REGULATORY INFORMATION DISTRIBUTION SYSTEM (RIDS)

SUBJECT: Forwards Rev 26 to "QA Program for Station Operation," in accordance with 10CFR50.54(a)(3). Rev 26 incorporates organization related changes associated with reorganization of Nuclear Operations Group & clarification of methods.

SUBJECT: Revised Submittal of Quality Assurance Program for
Station Operation
R. E. Ginna Nuclear Power Plant
Docket Number 50-244

Revision 26

FIGURE 17.1.2-1
Organizational Chart

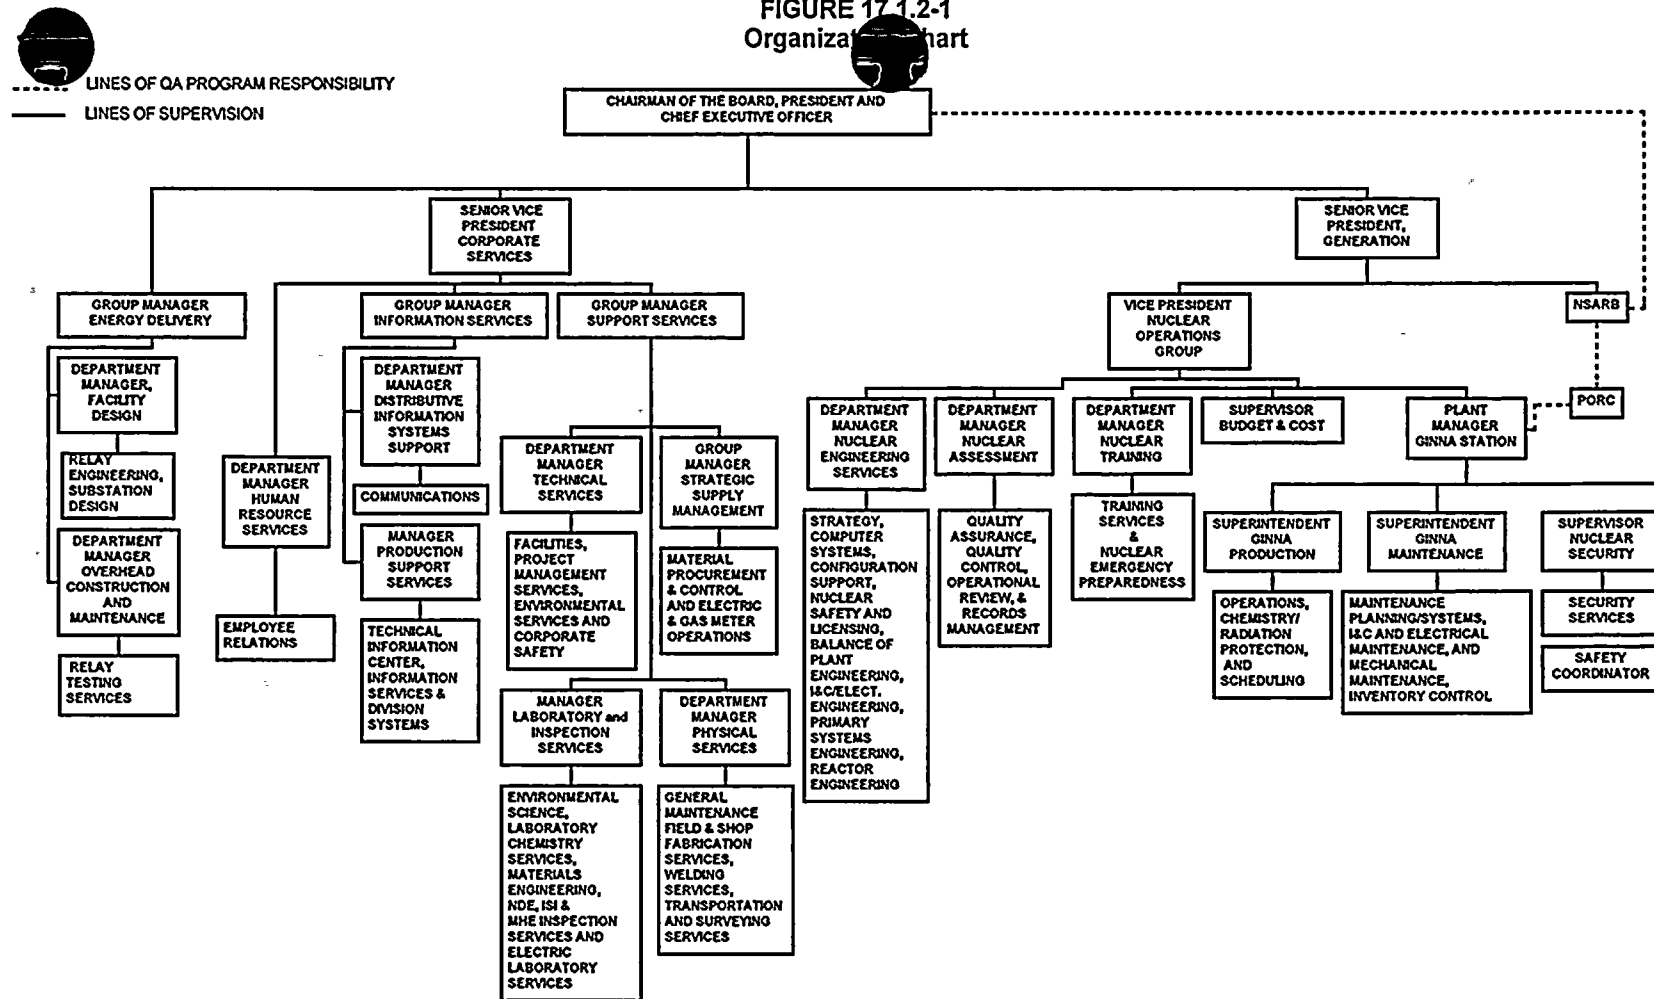
The following organization changes were made and are reflected throughout the text of the document and on the Figure 17.1.2-1 Organization Chart:

- The Department Manager, Nuclear Training now reports to the Vice President, Nuclear Operations Group. Additionally, the responsibility for Nuclear Emergency Preparedness was transferred from the Department Manager, Nuclear Assessment to the Department Manager, Nuclear Training.
- The positions of Director, Operating Experience and Manager, Nuclear Assurance have been eliminated. The responsibilities for these positions have been assumed by the newly created position of Manager, Operational Review.
- The responsibility for the fire protection program has been transferred from the Department Manager, Nuclear Engineering Services to the Plant Manager, Ginna Station.
- Nuclear Engineering Services reorganized internally. This change affected the Figure 17.1.2-1 Organization Chart only.
